EXPLANATION OF SIGNIFICANT DIFFERENCES

NYANZA CHEMICAL WASTE DUMP SUPERFUND SITE
(Operable Unit 2)

ASHLAND, MASSACHUSETTS

PUBLIC COMMENT DRAFT

Figure 4
Typical
Belt Skimmer

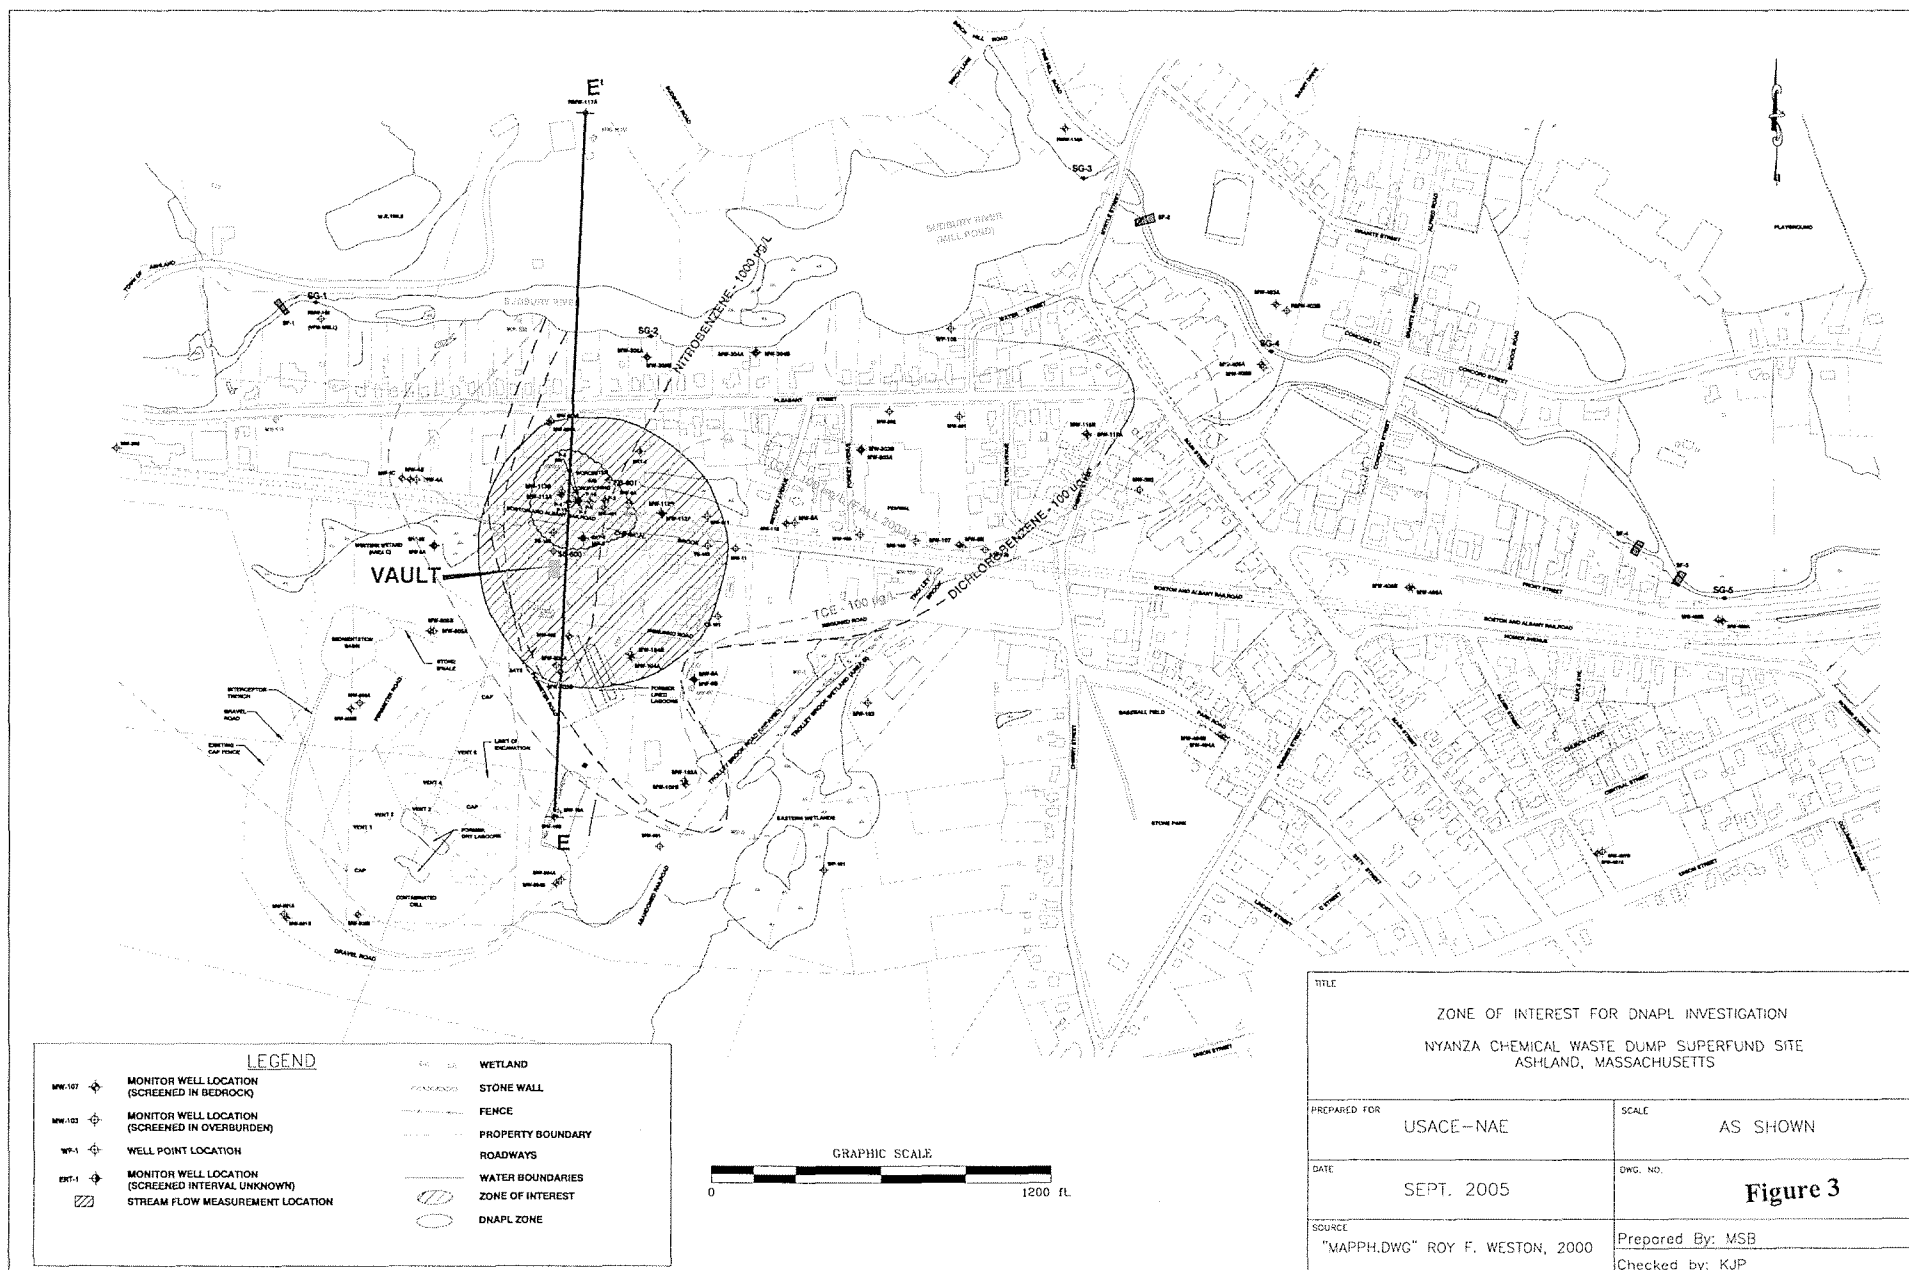
Source extraction of DNAPL involves the physical extraction of DNAPL from the deep aquifer, and possibly shallow bedrock fractures, through the use of belt skimmers, pumps or a similar extraction method, such as peristaltic and/or hydrophobic filter pumps, or intermittent use of a vacuum truck in wells with measurable DNAPL. Given EPA's uncertainty regarding the ability to locate and extract the DNAPL, EPA intends to employ various extractions methods, and use possible enhancements, to make every effort to effectively eliminate the DNAPL as an ongoing source of groundwater contamination. The preferred extraction method(s) will require a slow but continuous, or nearly continuous, extraction process matched closely to the DNAPL inflow rates. Belt skimmers employ this method and rely on the difference in surface tension between oil and water. A continuous loop oleophilic belt is passed through the free-phase DNAPL, which is then absorbed onto the belt and brought to the surface. The water is left behind. The DNAPL is removed by passing the belt through tandem wiper blades, which scrape off both sides of the belt. Regardless of the exact extraction method(s) to be used, once recovered the DNAPL will then be containerized in a tank or drums for off-site treatment. Given the specific physical qualities and location of DNAPL at the Site, recovery rates may be as low as 1 gallon of DNAPL per well per day. Up to 50 extraction wells may be installed. However given the difficult geologic conditions at the Site, and the inability to locate DNAPL in monitoring wells and soil borings installed during the investigation, belt-skimmers will initially be installed in 5 wells, and existing wells MW-113A and RW-1, to the extent practicable. Depending on the success of DNAPL extraction from these 5 to 7 wells, EPA may install additional extraction wells up to a total of 50, each equipped with a continuous loop belt skimmer, pump or a similar extraction method. The location of the proposed extraction wells, and exact extraction method(s) to be used shall be determined during the design phase. Figure 4 shows a general schematic of a typical belt skimmer system.

Figure 5

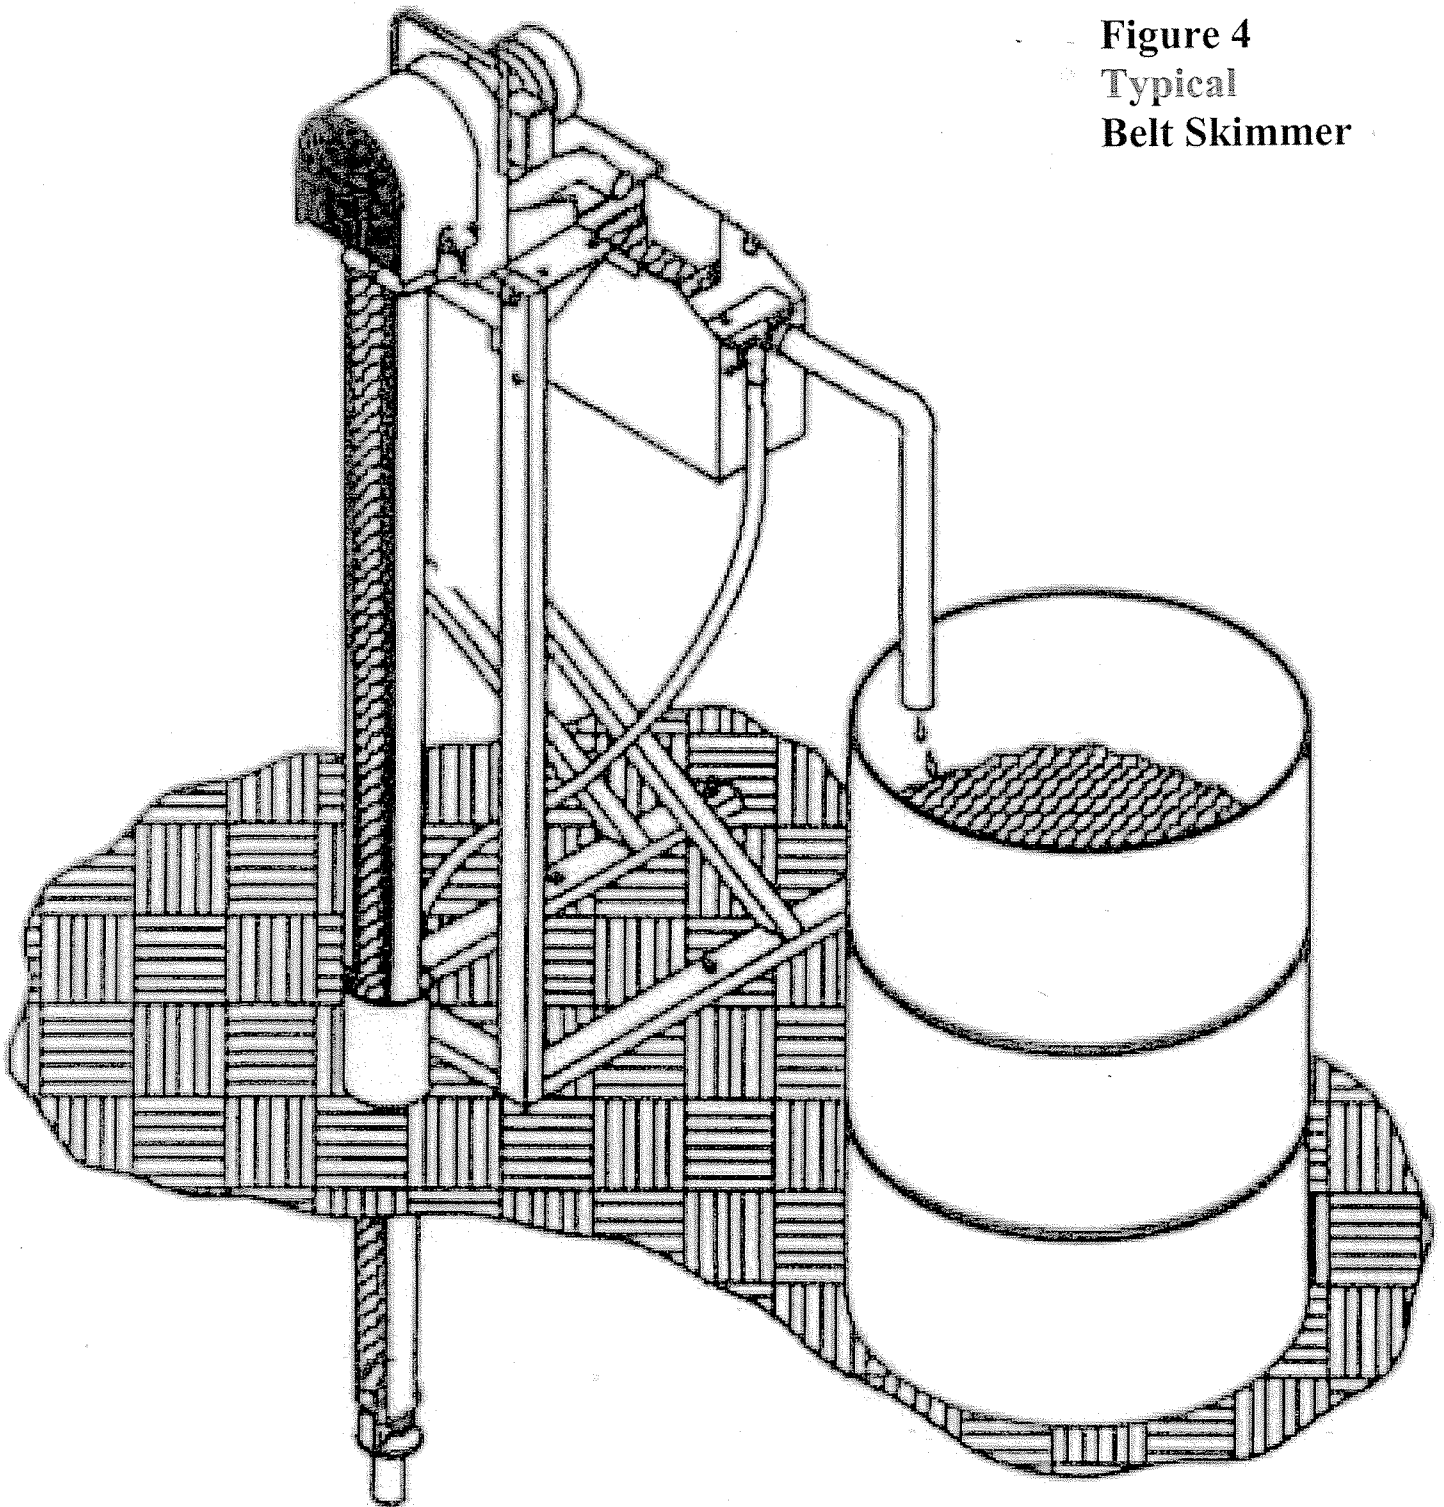
The active vapor mitigation systems consist of small diameter PVC pipes, which are attached to a continuously operated fan. The system works by installing one or more pipes through the basement floor and into the sub-slab area. The piping is then routed outside the home and above the roof line where the vapors are allowed to discharge into the atmosphere. Once discharged, the vapors are diluted and no longer pose a potential threat. A single small-diameter 90 watt fan is placed along the piping route (outside) to maintain a positive pressure and continually draw the vapors from the sub-slab to the atmosphere. A diagram of a typical active vapor mitigation system is shown in Figure 5.
